# STATEMENT OF ENVIRONMENTAL EFFECTS

APPLICATION FOR 4.55 MODIFICATION OF DEVELOPMENT CONSENT DA2020/0706 :

42 UPPER CLIFFORD AVENUE, FAIRLIGHT

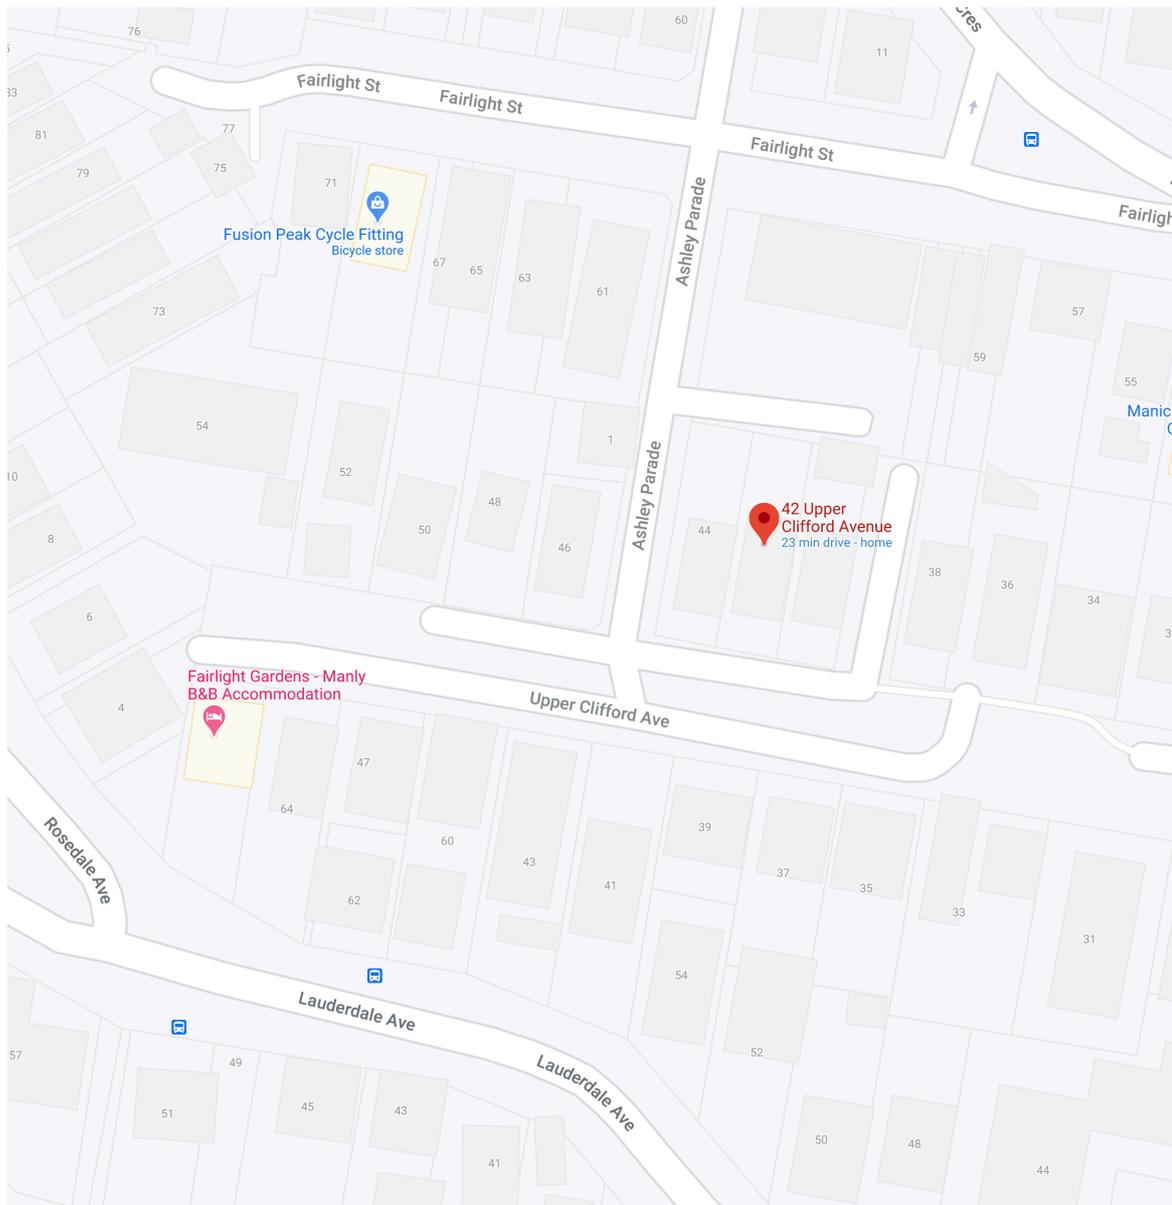
The modification seeks approval for a modified version of the originally proposed garage to address the concerns raised by the Council's development engineer.

The amended design addresses the development engineer's concerns by :

- Amendment of noted RL's on the drawings in accordance with an amended topographical survey which captured significantly more spot levels than the original survey, particularly in respect of the public footpath and the kerb.
- Splitting the proposed garage into two distinct spaces with a 1.0m high internal dividing wall to separate the two spaces
- Extending the length of the eastern half of the proposed garage to alter the levels of the parking space within the garage
- Amendment to the direction of egress through the pedestrian door
